Geometry Board Design

DUNE Electronics Review

2019 November 18

ProtoDUNE PCB Design Metrics

X Head Board Design Check

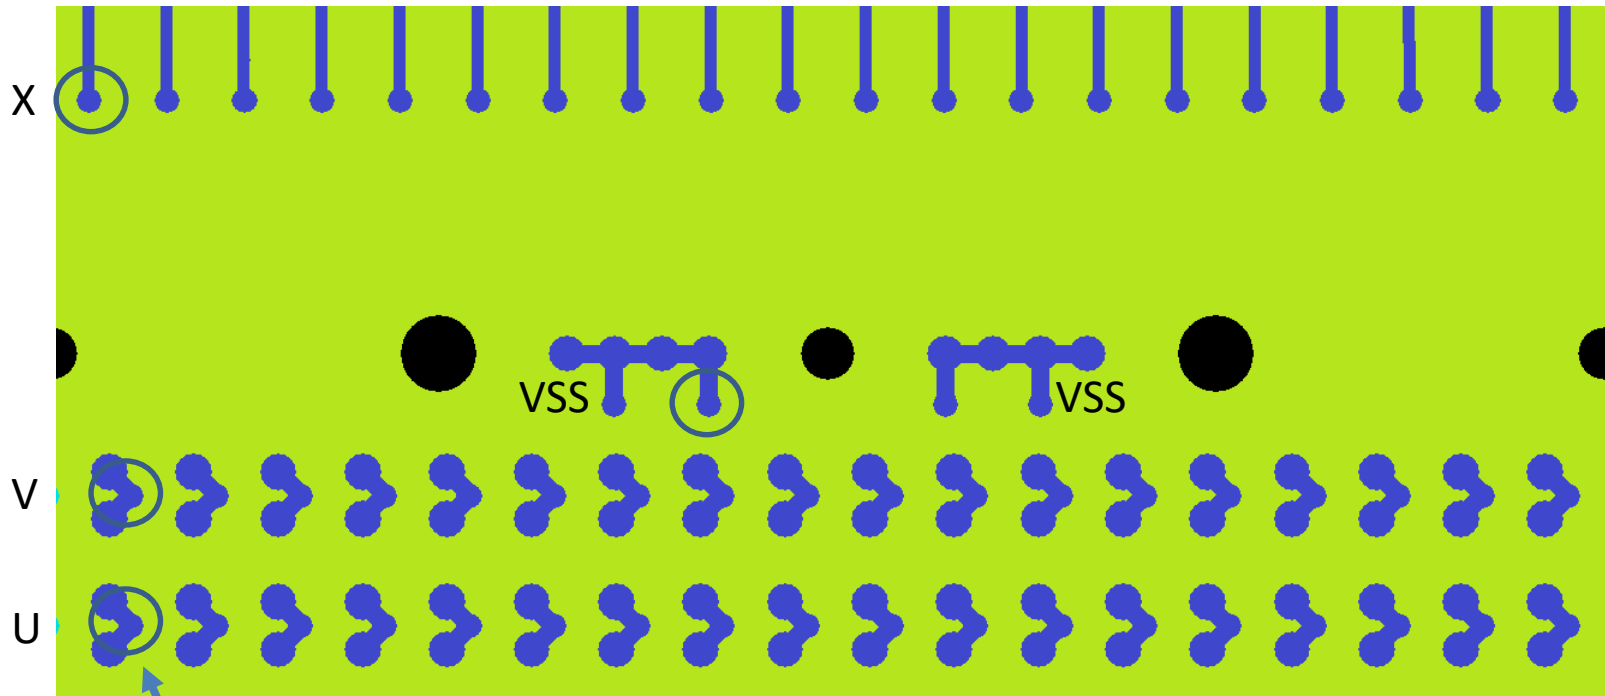
Features	Minimum Separation (S) mm	Possible ΔV Volts	Meets IPC?	Safety Limit ¹ = S * 1kV/mm Volts
U and V traces (long-term)	2.5 uncoated	400	Yes	2500
ΔU and ΔV (wire tension)	2.1 uncoated	500	No	2100
ΔX (wire tension)	2.2 uncoated	500	No	2200
ΔX (wire tension)	0.81 coated	500	Yes	N/A

V Side Board Design Check

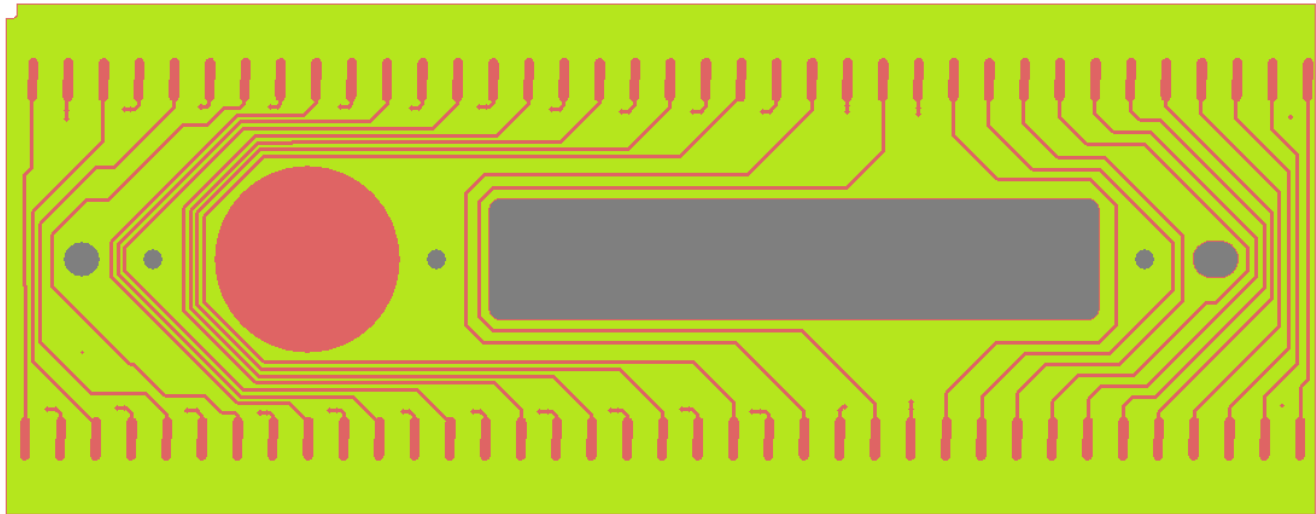
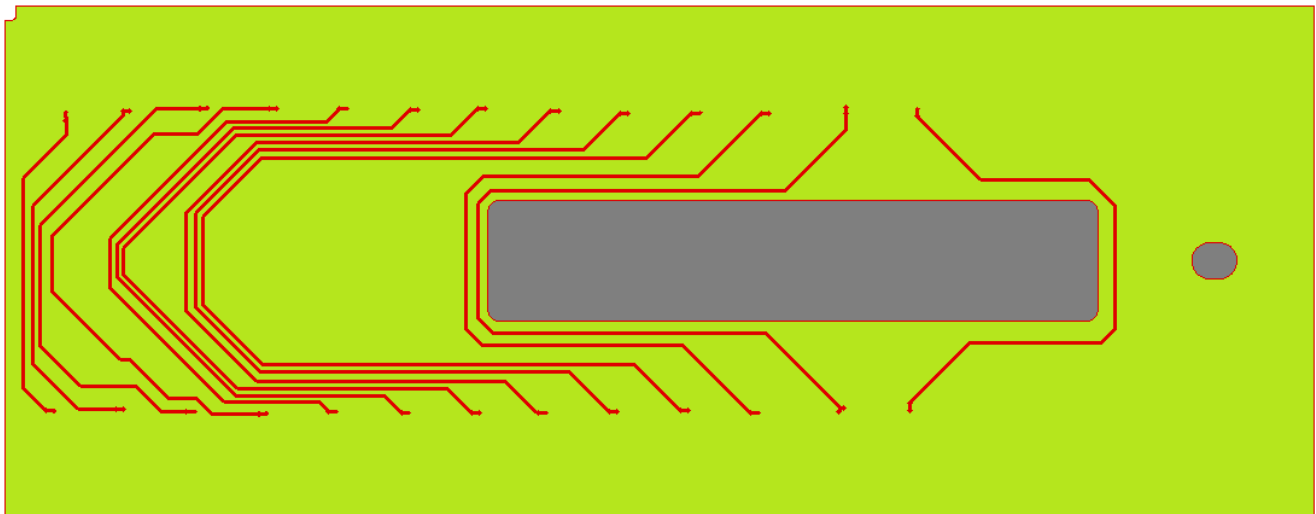
Features	Minimum Separation (S) mm	Possible ΔV Volts	Meets IPC?	Safety Limit ¹ = S * 1kV/mm Volts
ΔV (wire tension)	5.8 uncoated	500	Yes	
ΔV (wire tension)	0.80 coated	1000	No	N/A
ΔV (wire tension)	0.80 internal	1000	No	N/A

- A sample board had 2000 Volts applied between all adjacent traces on the top and internal layers for 15 minutes with no breakdown (Hi-Pot test threshold 100 nA)
- This board will be re-designed to reduce or eliminate occurrences where adjacent wire traces are biased more than 500 Volts during electronic wire tension testing
